GENERAL DESIGN INFORMATION

Justification for Proposed Erosion Control Measures at 1087 Lawnes Neck Drive, Smithfield, VA

Figure 9. Proposed revetment design.

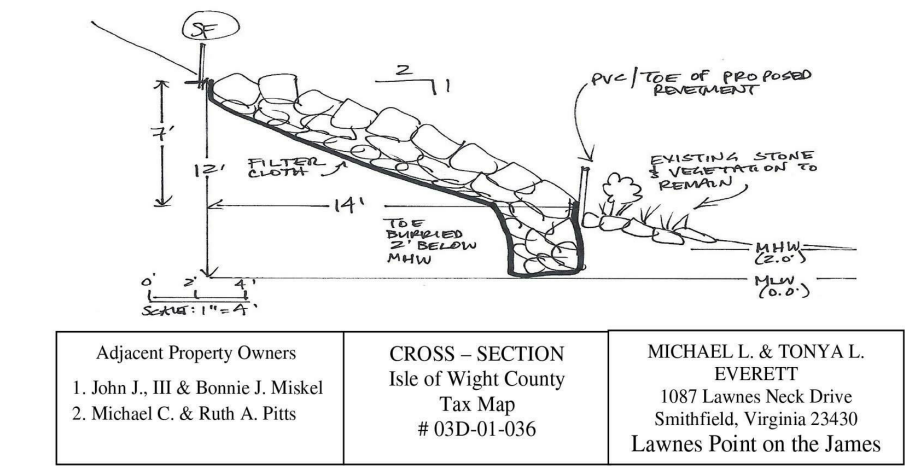
IOW: As stated in the *Guidance Manual*, "in order to be consistent with the Regulations, a shoreline erosion control measure must be based on the 'best available technical advice.' The applicant should seek the advice of a shoreline engineer or some other erosion control specialist such as staff from the Department of Conservation and Recreation."

IOW: This project proposes to remove all vegetative cover from the embankment and then treat with a riprap revetment and planting. Yet SEAS is recommending that there be only selective cutting or trimming of vegetation from within 25 feet of the embankment edge. Please present a plan that incorporates this recommendation and that preserves the existing vegetative cover as much as possible.

Install a riprap revetment on the reggraded embankment with 2:1 slope as shown in Fig. 9. The revetment will extend from near MHW to an elevation of 11 feet above MLW. This will protect the shoreline against impacts from 100-year storm intensities. The remnant riprap from the failed revetment will be left on the beach to act as an apron providing additional protection to the shoreline.

The applicants have also consulted with numerous marine contractors (all of which visited the site), including Mr. Robert Simon (Waterfront Consulting, Inc), Mr. Kevin Pankoke (Pankoke Marine Construction), and Mr. Joe Foulis (Waterfront Construction and Design, Inc). All of these marine contractors have extensive experience in design and installation of shoreline stabilization measures in the Tidewater Virginia area. They all recommended similar measures as we propose in our application. Mr. Joe Foulis (Waterfront Consulting, Inc.) designed the proposed revetment shown in Fig. 9.

Figure 10. Schematic showing existing vegetation and terrain in RPA.

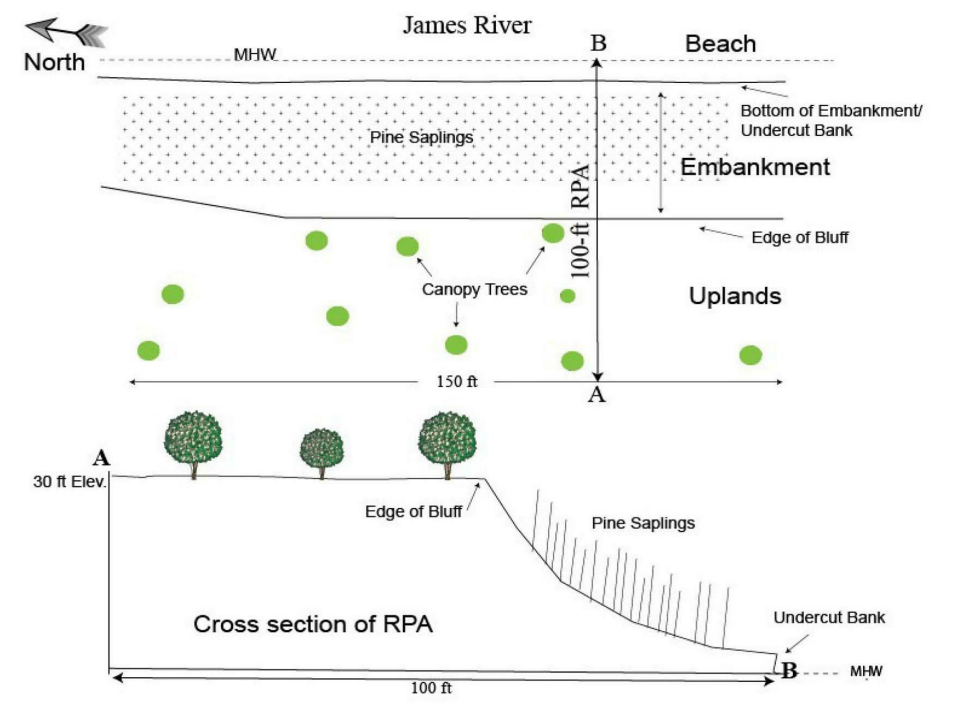
IOW: Land disturbance has been maximized with the plan to remove all vegetation from the embankment, which immediately creates an erosion problem where none has existed previously. "The intent of the Regulations is to retain a functioning vegetated buffer, preferably a naturally forested one, while allowing filtered views to the water. Providing sight lines through the buffer should be accomplished with the least amount of disturbance to the existing vegetation," as stated in Chapter 3.1 of the *Guidance Manual*. If a view of the James River is wanted, then working with staff to create a plan for limbing up or selective removal of some trees can be done to create a narrow line-of-sight view to the water, once the house has been built and the line-of-sight can be established.

Response: Based on site visits and follow-up discussions with shoreline engineers from DCR and other agencies, we conclude that there is clear evidence of active, detrimental erosion at our site. The erosion is focused in two areas: (1) shoreline and fastland erosion at the beach due to wave energy and (2) erosion of the face of the bluff above the shoreline with no functional riparian buffer. Instead of "creating an erosion problem where none has existed previously," our proposed project will mitigate the ongoing erosion problem and result in a much more stable shoreline with a functioning riparian buffer in the long term. The fundamental goal of our project is not to improve our view of the James River, it is to stabilize the shoreline and embankment to protect our investment in waterfront property and reduce the risk of further significant erosion from intense storms and sea level rise. The magnitude of the land disturbance is in scale with the erosion control measures necessary to stabilize the shoreline and embankment. It is important to note that nearly 50% of the RPA (in the uplands above the bluff) will NOT be disturbed by this project.

Figure 11. Proposed planting mitigation on embankment.

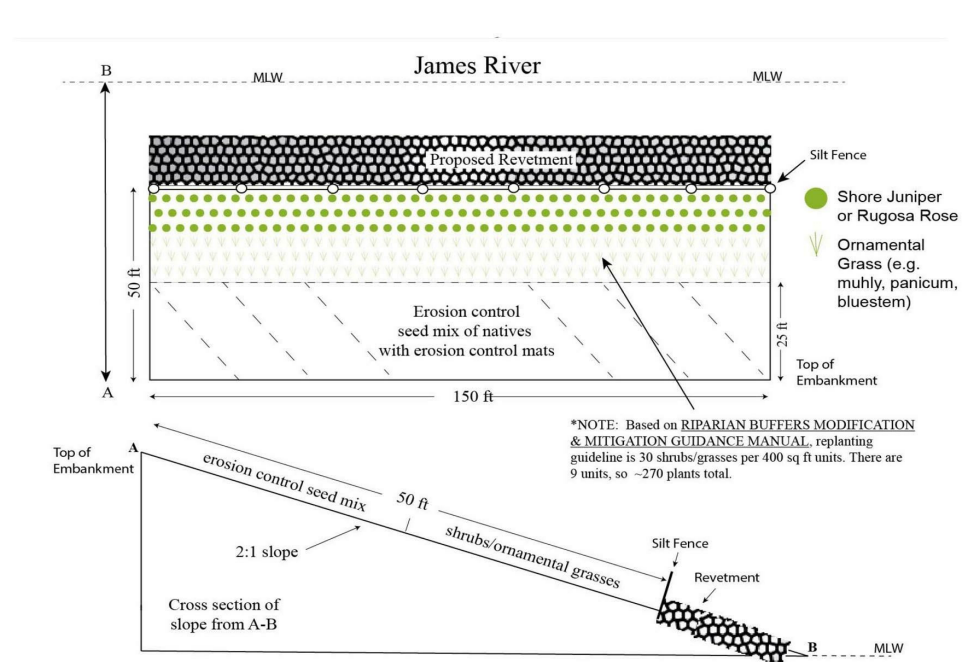
IOW: The *Guidance Manual* is based on a 1-2-3 formula for re-forestation for every 400 square feet. That is, one canopy tree, two understory trees and three small shrubs. The proposed plan based on shore juniper and rugosa rose does not achieve re-forestation as presented by the regulations. Please present a plan based on the recommended 1-2-3 formula with as little removal of existing native vegetation as possible.

Therefore, we propose to replant the disturbed area above the revetment with a combination of native grasses and shrubs as shown in the landscaping plan in Fig. 11. To minimize potential erosion of the newly graded embankment, the planting will occur immediately after the final grade is reached and mulch will be spread to protect against erosion while the new vegetation becomes established. Selected removal of canopy trees growing in the RPA above the bluff will be mitigated based on guidelines for replacement set forth in the *Guidance Manual*.

Response: Our planting mitigation plan is based on written guidance received from the IOW Environmental Planning Office that we would not be required to replant canopy trees on the reggraded embankment and instead should replant with native grasses and shrubs at a rate of 30 plants for every 400 square feet. Since only about 50% of the RPA will require replanting, these vegetative replacement rates seem appropriate and are consistent with other recently approved projects along the James River in IOW County. As discussed above in **Proposed Erosion Control Measures**, the *Guidance Manual* does NOT recommend planting canopy trees on slopes near revetment structures.

Figure 12. Equipment access path to project.

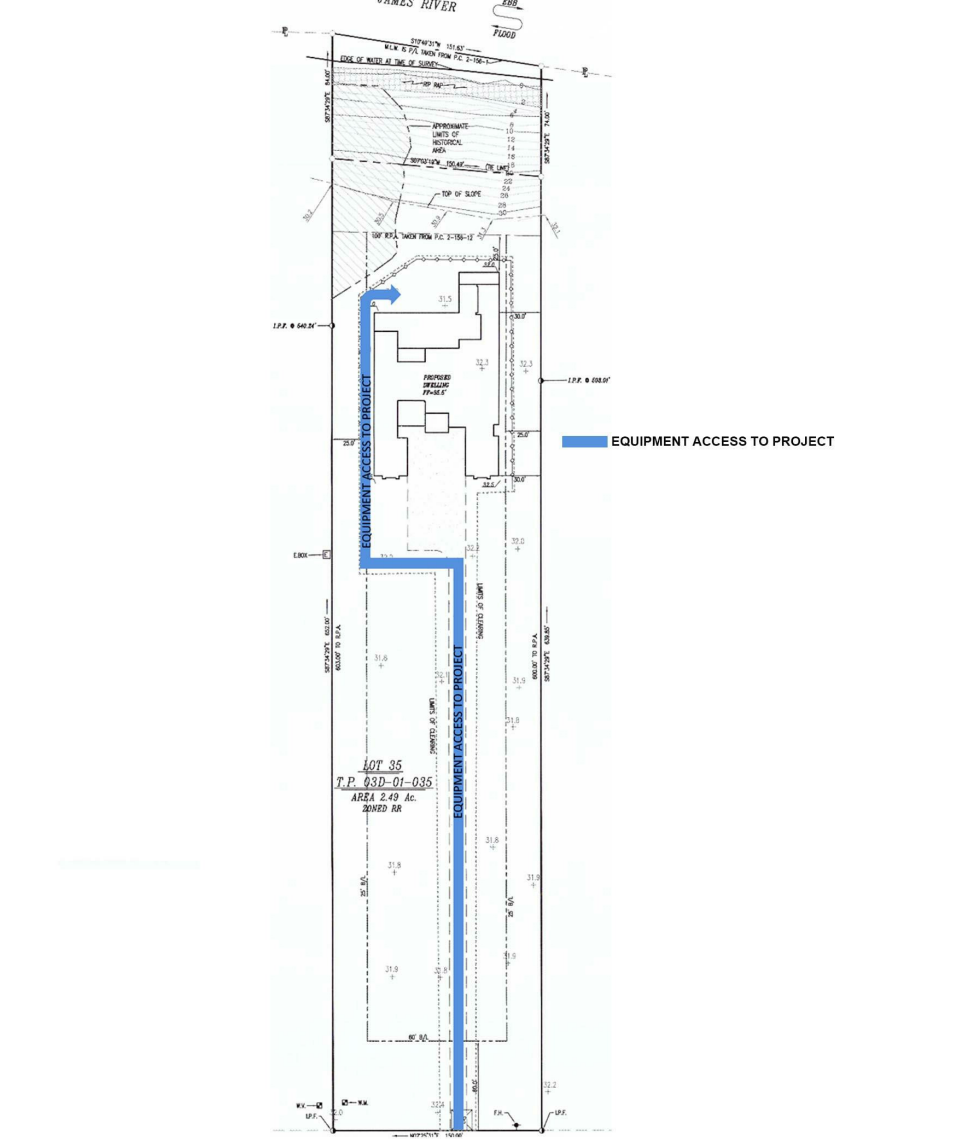
IOW: Staff cannot evaluate this as there is very little information on access to the project area.

Please provide a detailed plan showing the full route of access with minimal land disturbance.

Response: General access to the project location will be provided by a construction road that will be built to access the house building site. This construction road will ultimately become the driveway to the house, so no additional land disturbance will be required to accommodate our project. The project site is approximately 100 feet beyond the house construction site. An access path for equipment will be extended from the existing construction road out to the project site through the woodlands behind the house site. The width of the access path will be approximately 15 feet to accommodate passage of equipment and trucks. The exact path through the woodlands will be selected to avoid additional tree removal. Figure 12 shows a schematic of the location of the access route to the project.
